MEMORANDUM

Subject: 2117 W. 49th, and 4709 Rosedale Ave Multifamily NTA | C14-2025-0094

Figure 2: Tube count locations

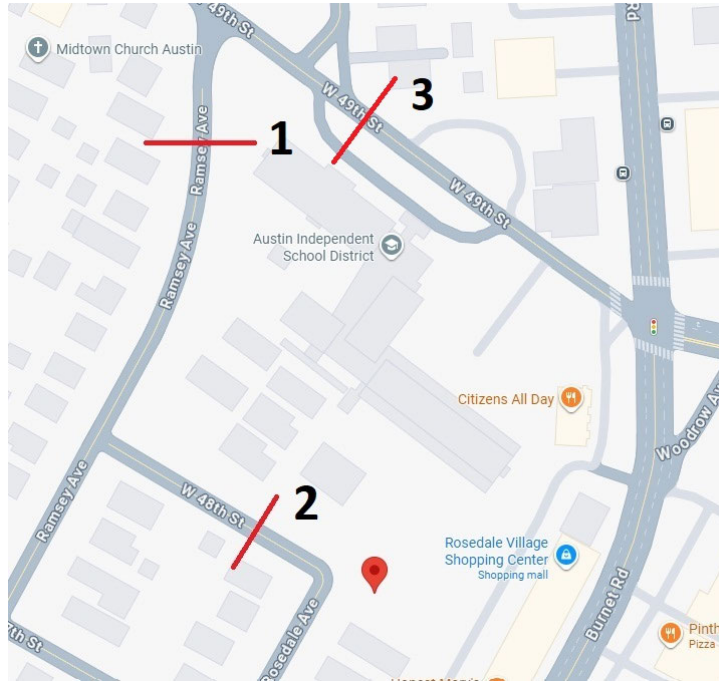
24-hour traffic volumes were collected at two points, see Figure 2 below, on Ramsey Ave and

W 48th St, on September 23rd, 24th, and 25th, 2025. Additionally, traffic volume was collected on W 49th St on September 23, 2025.

POTENTIAL RECOMMENDED IMPROVEMENTS

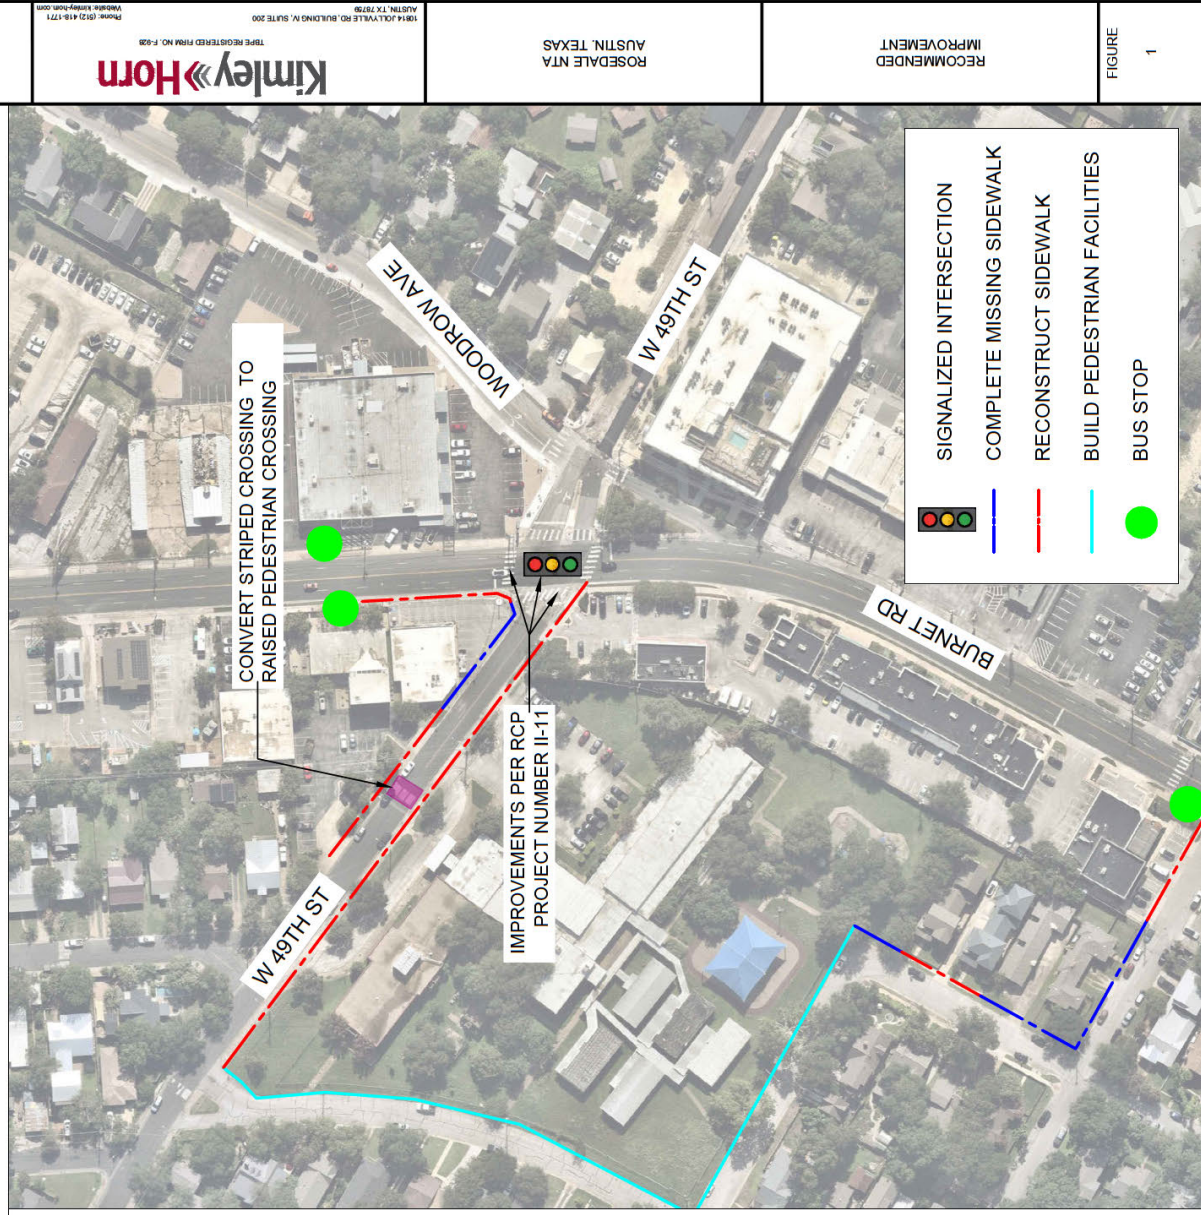
The area around the site was analyzed to identify potential transportation improvements to be implemented at the time of site plan. The 'Recommended Improvement' exhibit attached at the end of this memo identifies several potential improvements based on this review. Improvements identified in this memo are recommended for the applicant to construct at the time of site plan to achieve the TDM reduction target and mitigate traffic impacts.

2. During the site plan review, the developer will be required to re-construct sidewalk on W 49th St along the site's frontage
3. During site plan review, it is recommended the developer construct the following sidewalk improvements to achieve TDM plan trip reduction target.

- a. Along the north side of 49th St west side of Burnet Road between Lynwood St and the existing transit stop.
 - b. Along the east side of Rosedale Ave and north side of 47th St between 48th St and the transit stop.

4. During site plan review, it is recommended the developer construct a mid-block, raised pedestrian-crossing across 49th Street.
5. As per the ASMP, the required ROW for Ramsey Ave, W 49th St and W 48th St is either 58 or 64 feet.
